**NOTICE OF REGULAR MEETING AGENDA
HISTORIC LANDMARK PRESERVATION COMMITTEE
MUNICIPAL CENTER CITY COUNCIL CHAMBERS
211 N. HENRY STREET, LANCASTER, TEXAS**

2. HLPC21-08 Discuss and consider a Certificate of Appropriateness (COA) for the installation of solar panels on the property addressed as 305 East 4th Street, City of Lancaster, Dallas County, Texas.

HLPC21-08 Discuss and consider a Certificate of Appropriateness (COA) for the installation of solar panels on the property addressed as 305 East 4th Street, City of Lancaster, Dallas County, Texas.

1 PV Racking & Roof Framing Plan
Scale: 1/8" = 1'-0"

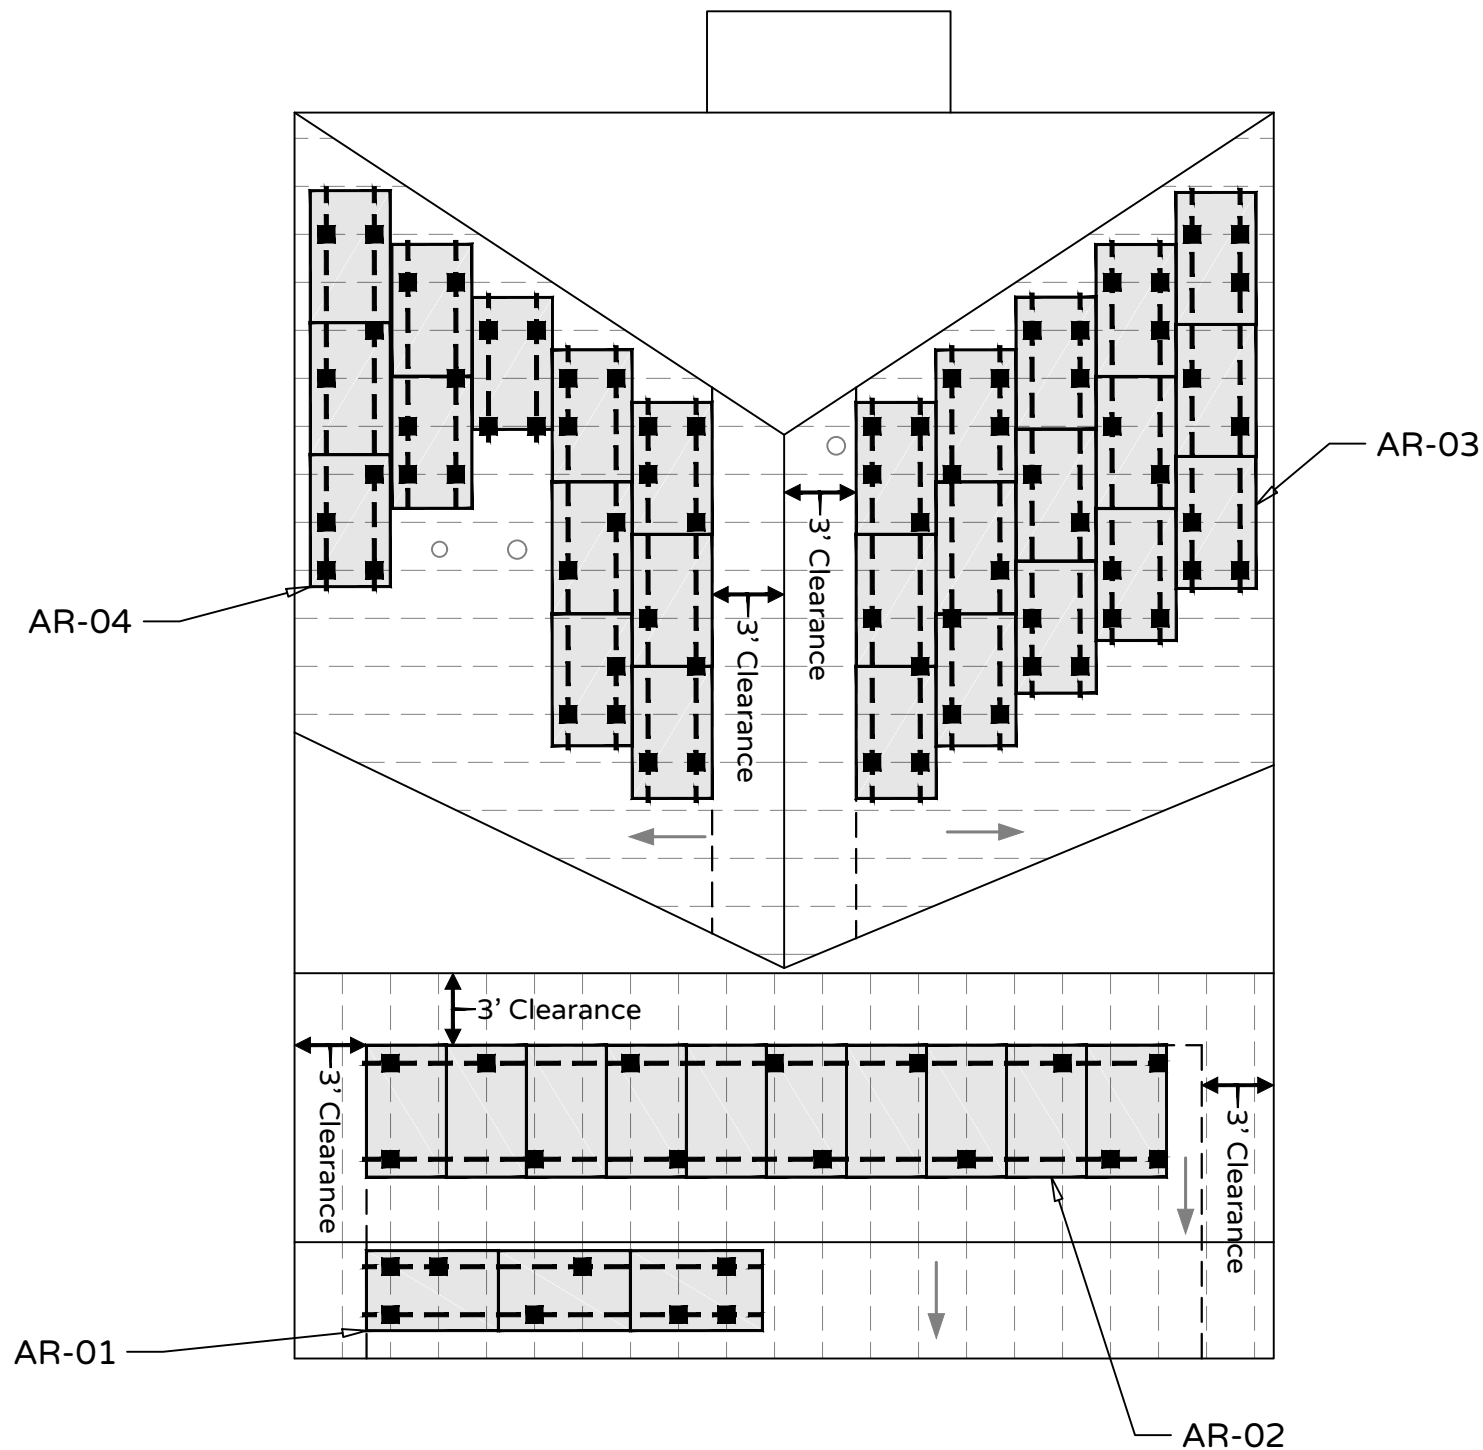
The applicant is requesting to install black solar panels on the front and sides of the roof on the home. The solar panels will be visible from the street. The applicant has indicated that it is necessary for the solar panels to be located on the east, west, and south sides of the roof in order to obtain optimal sunlight.

roofing material so they are less obtrusive." The proposed solar panels are not in compliance with the LHRDR as the solar panels will be located in the front and sides of the roof and will be visible from the public street. The color of the panels will be black and the color of the home's roof is grayish tan, as such, the solar panels and roof will be contrasting in colors.

Staff recommends the solar panels be placed on the roof where they are not visible from the front street or use panels that have the same color as the roofing material so they are less obtrusive to meet the LHRDR requirement.
